# City of Santa Fe, New Mexico

# memo

2025-011536-HDRB, 516 Alto St., Westside-Guadalupe Historic District, Contributing, Marc Naktin, agent for Steven Dayton, owner, requests approval to construct a 210 sq. ft. addition to a height of 14'-1" where the maximum allowable height is 16'-0".

**Figure 1. Proposed Site Plan.**

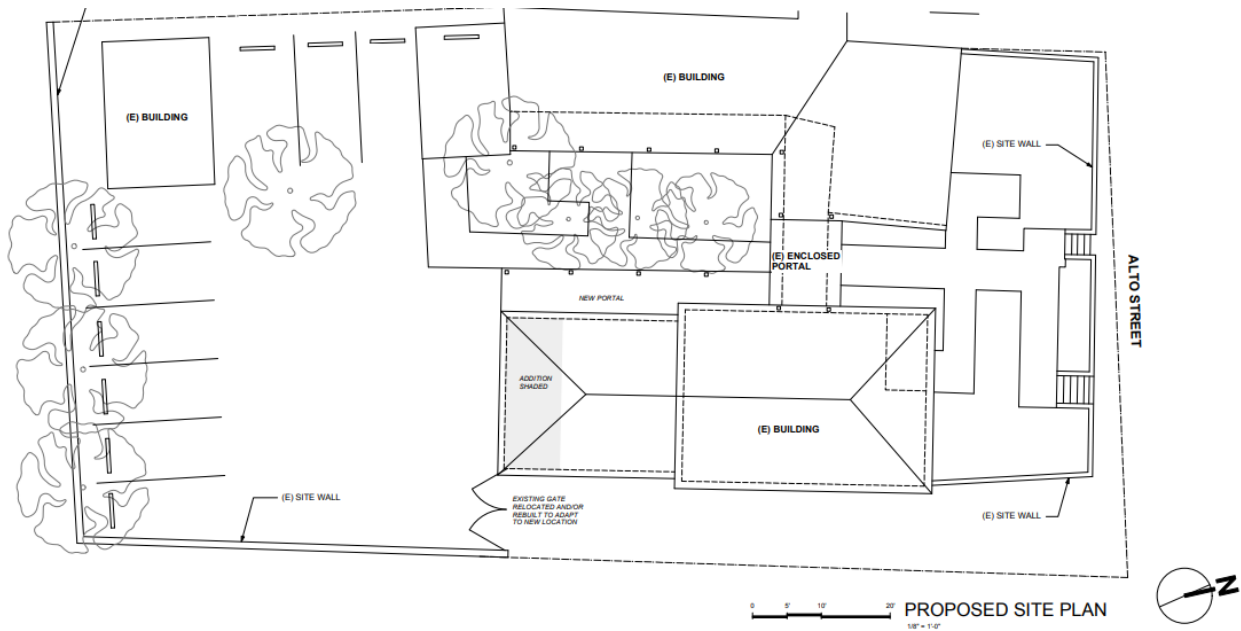
- 1) Construct a 210 sq. ft. addition to the south façade to a height of 14’-1” where the maximum allowable height is 16’-0”.
